## Fwd: CH 25 comments

From: Hannes Stueckler <hannes.stueckler@wyo.gov>  
Date: Mon, Feb 4, 2013 at 5:07 PM  
Subject: CH 25 comments  
To: William Tillman <william.tillman@wyo.gov>

To: Bill Tillman  
 From: Ronald Ewald, Assistant Southeast District Engineer  
 Water Quality Division, Wyoming DEQ  
 Date: February 27, 2013  
 Subject: **DRAFT2 Chapter 25 – Comments, Questions, and Concerns**

FIGURE 1

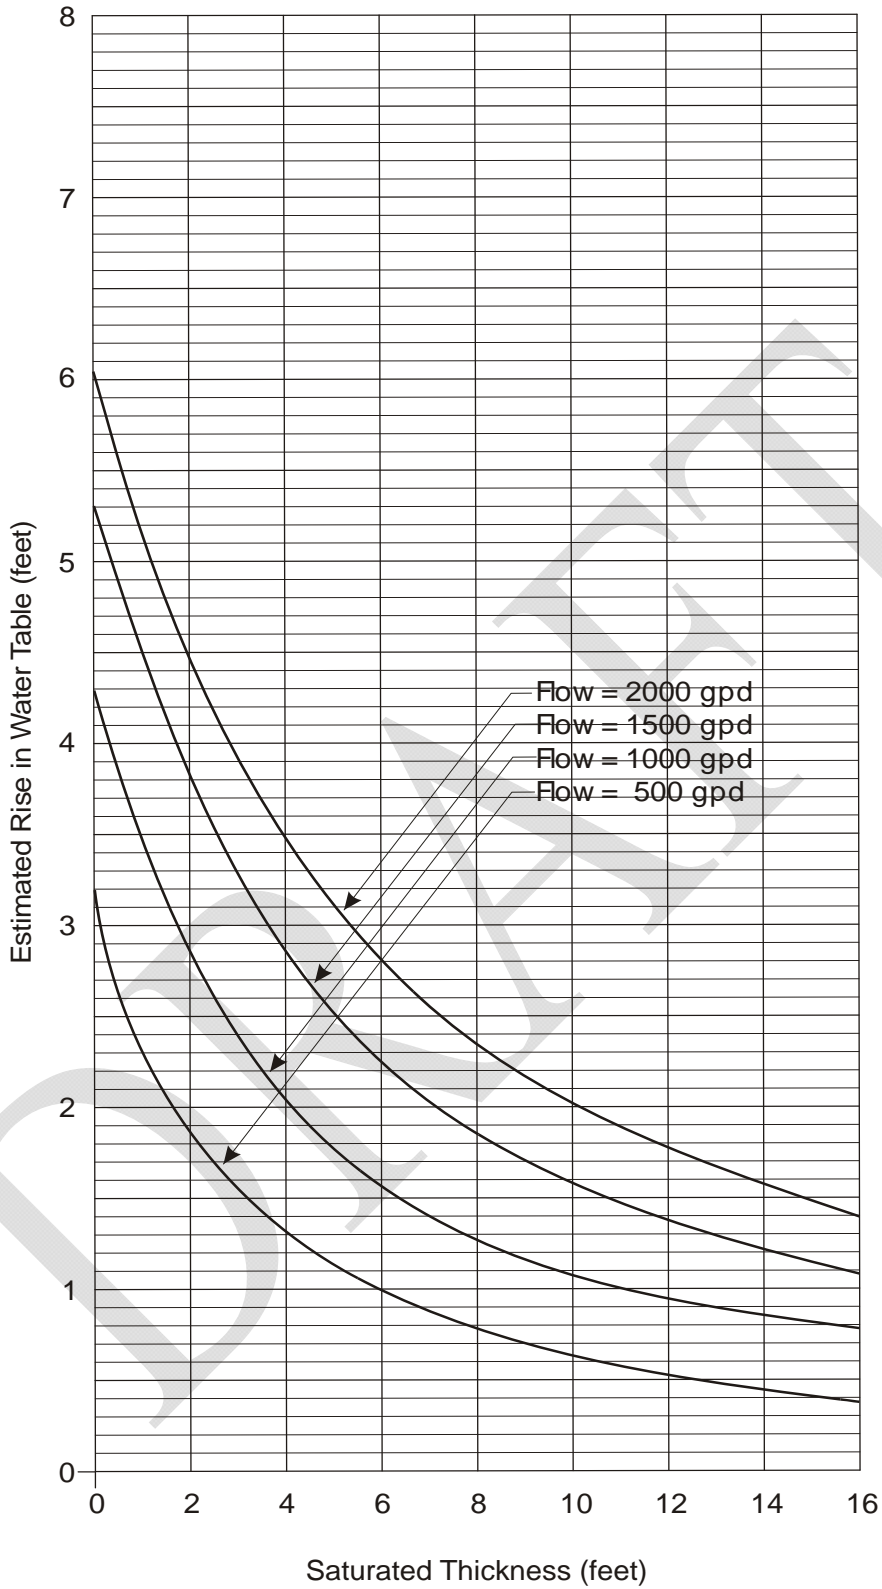
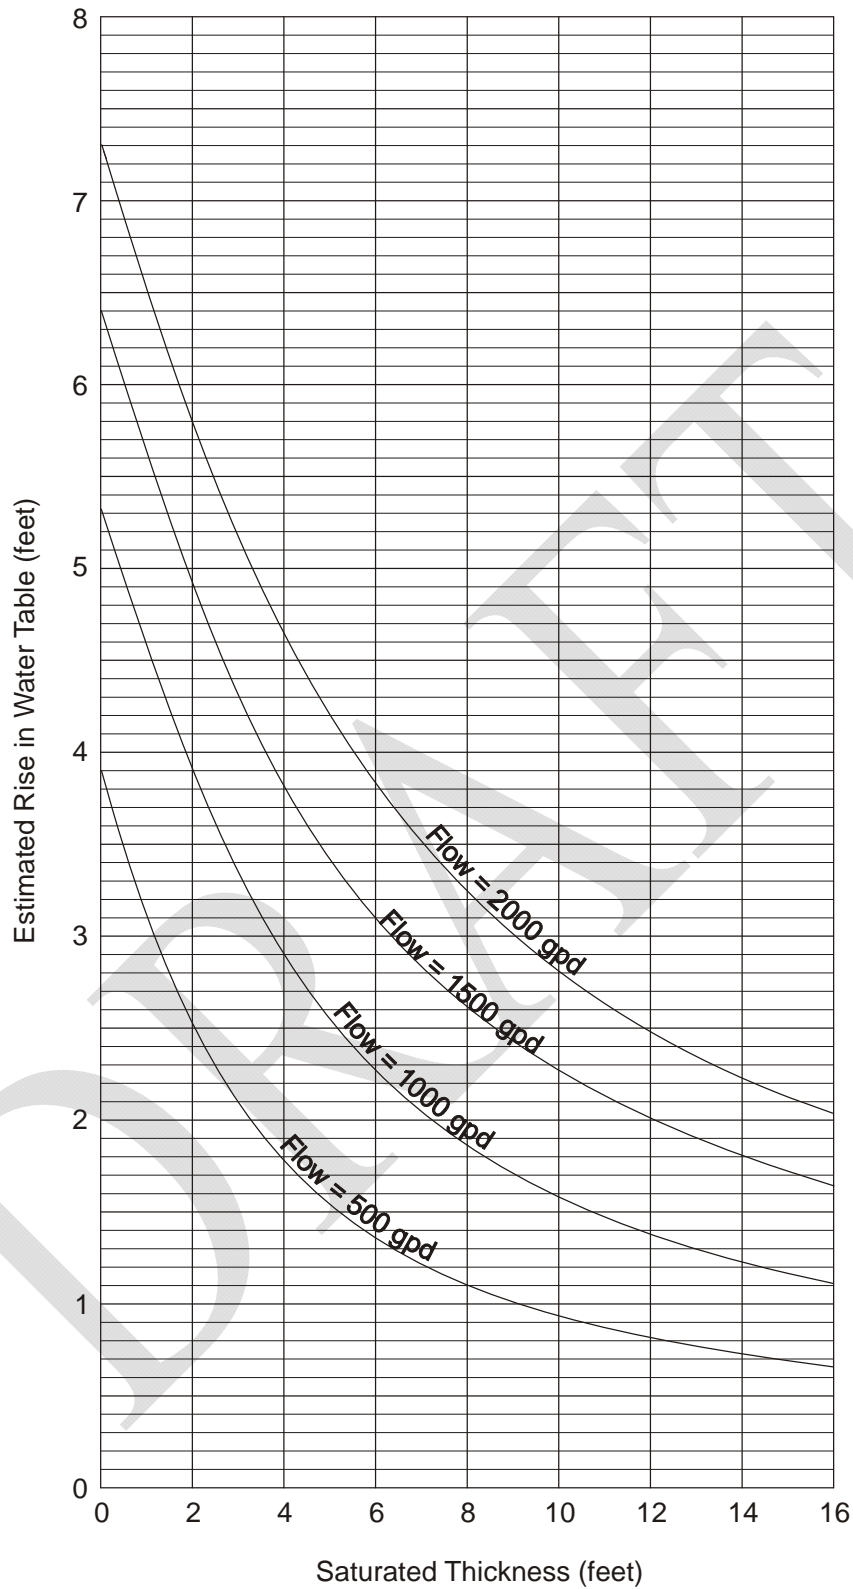
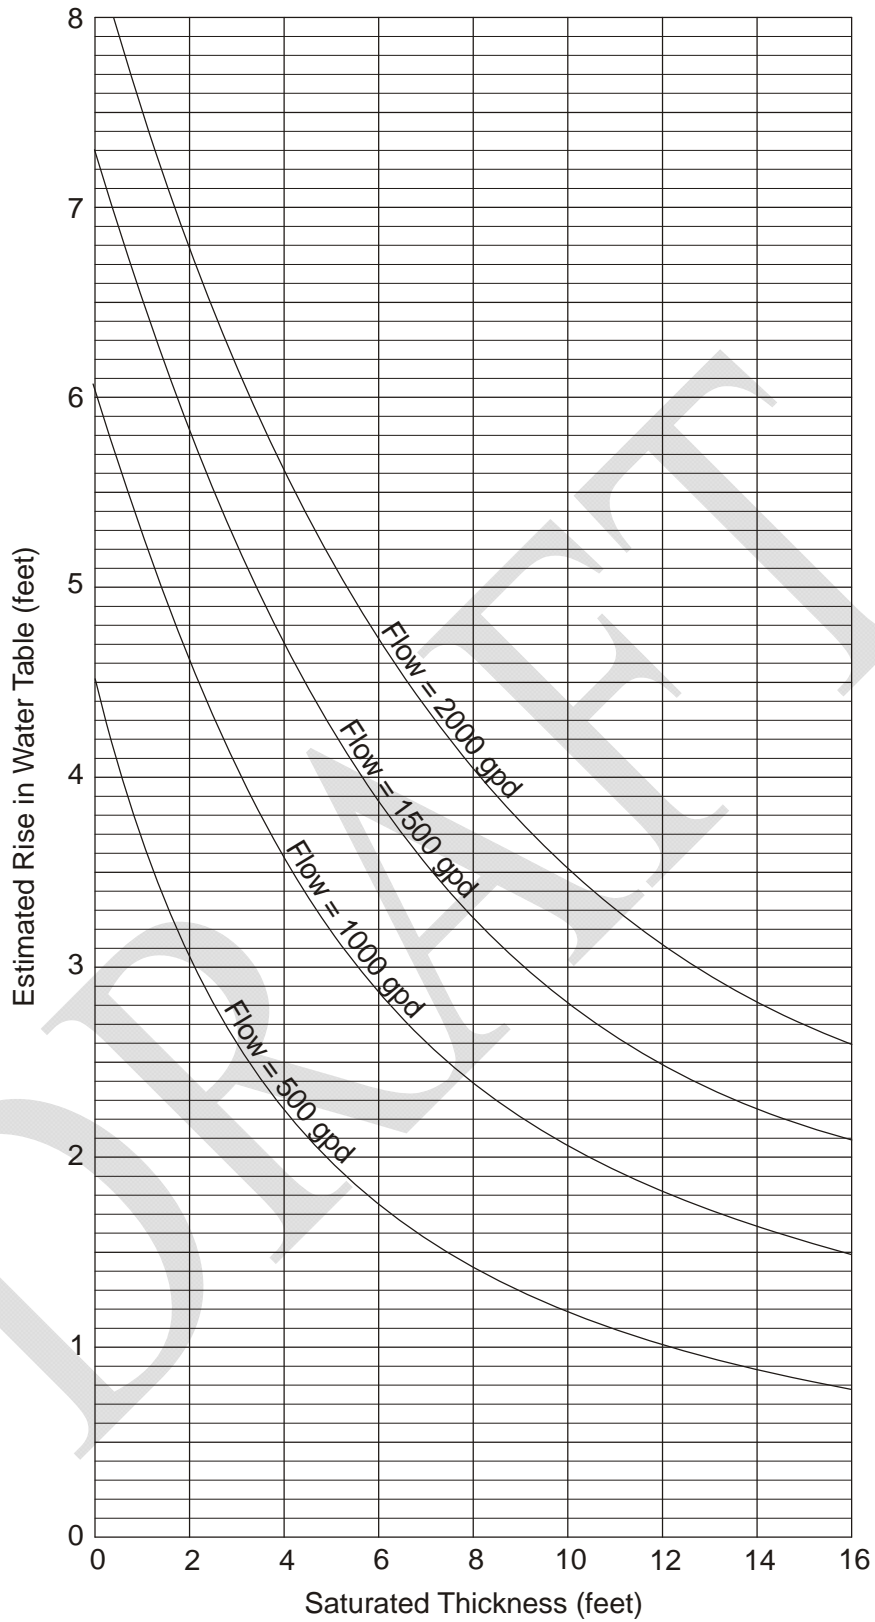
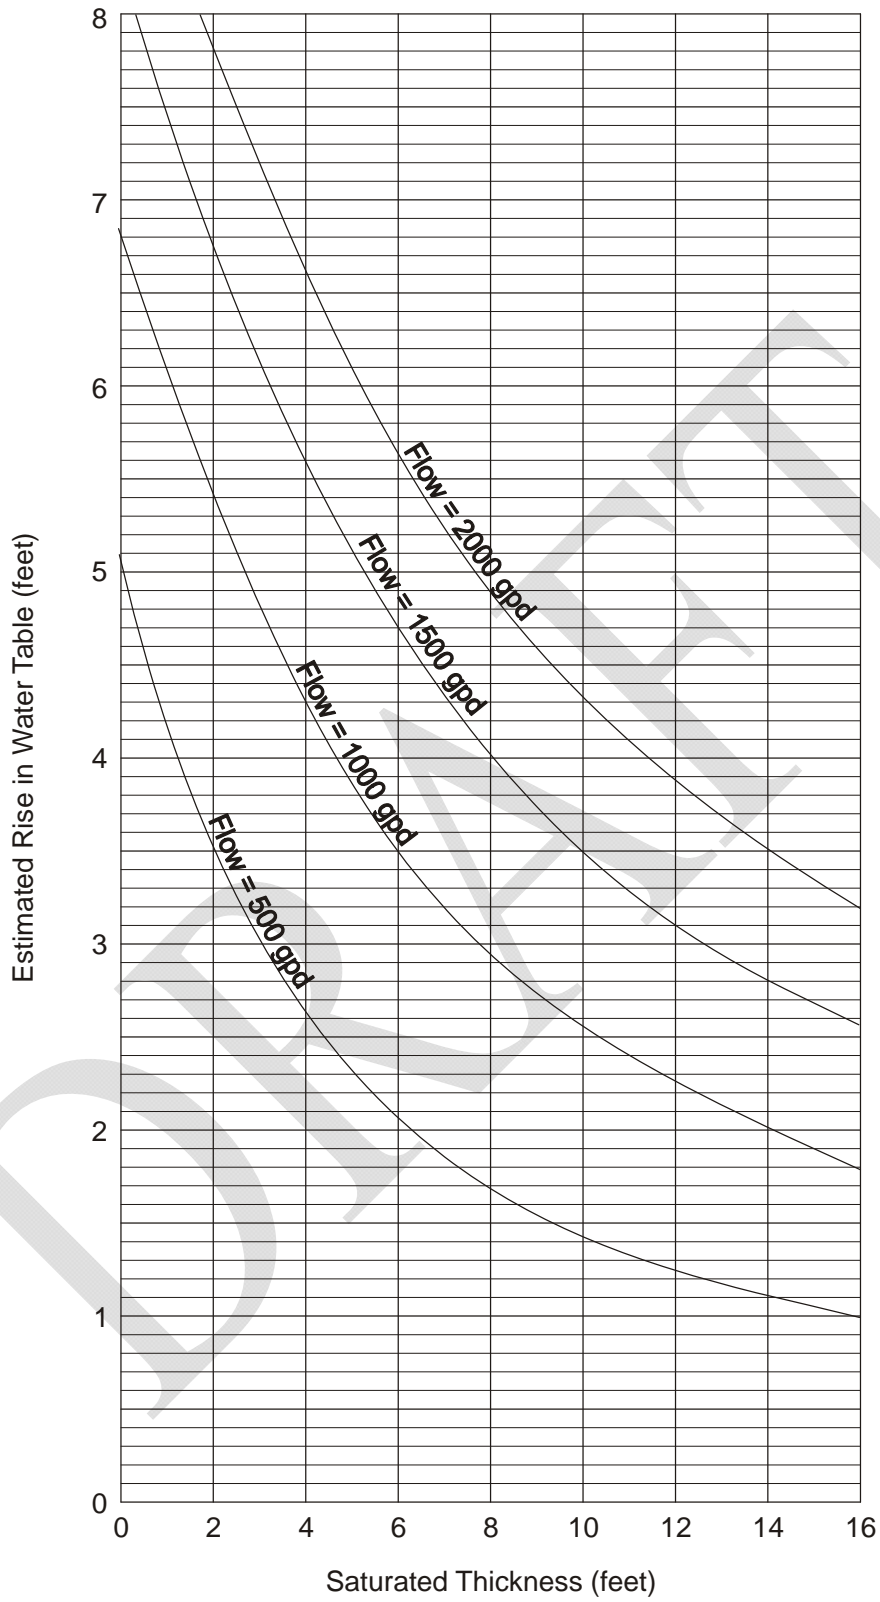
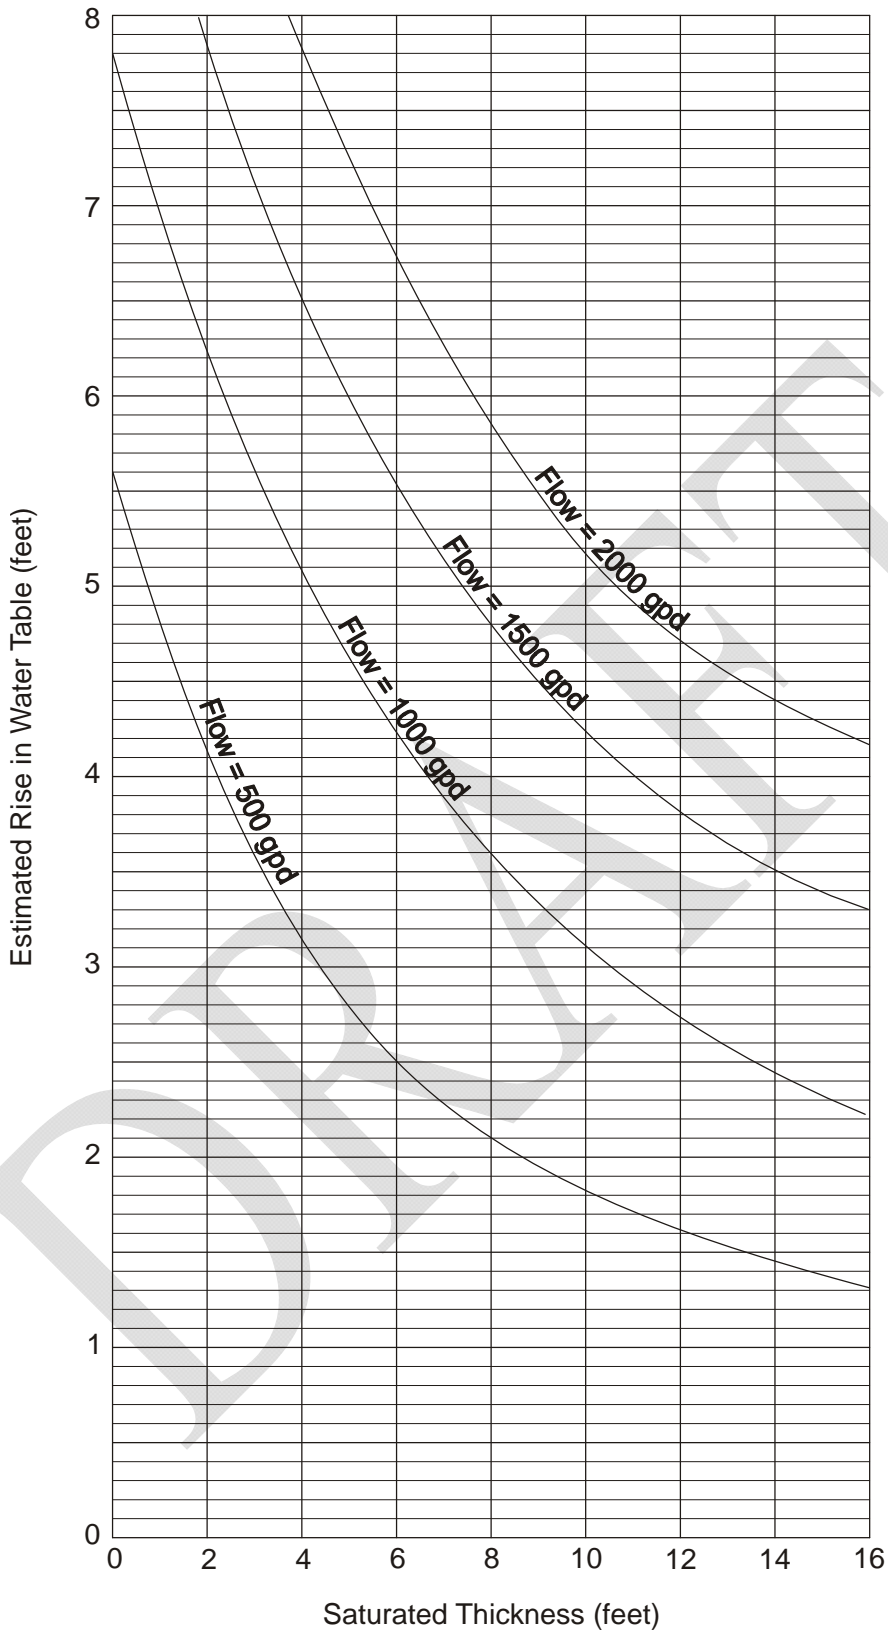
**Under Section 6. Site Suitability.** In item (d) reference is made to the estimated rise in the water table shown on figures 1 through 6. There needs to be an explanation of what is meant by the saturated thickness and how and when it is to be used along with the basis for figures 1 through 6. What is the source of these figures is it analytical, empirical or statistical or some other results? For example if there is no ground water present below the proposed leach field the saturated thickness curves indicate a rise in the groundwater level. How can there be a rise if there is no groundwater?

- Figure 1-6: Since these regulations are intended for use by non professionals, I think you should define “saturated thickness”.
- Table 4. Minimum horizontal setbacks from public water supply wells of 500 feet for septic tank and 1000 feet for absorption system could be impossible for some transient public water supply systems, seems excessive for a system under 2000 gpd, doesn’t take into account the vertical unsaturated separation, nor the treatment level that could be provided by an advanced system.
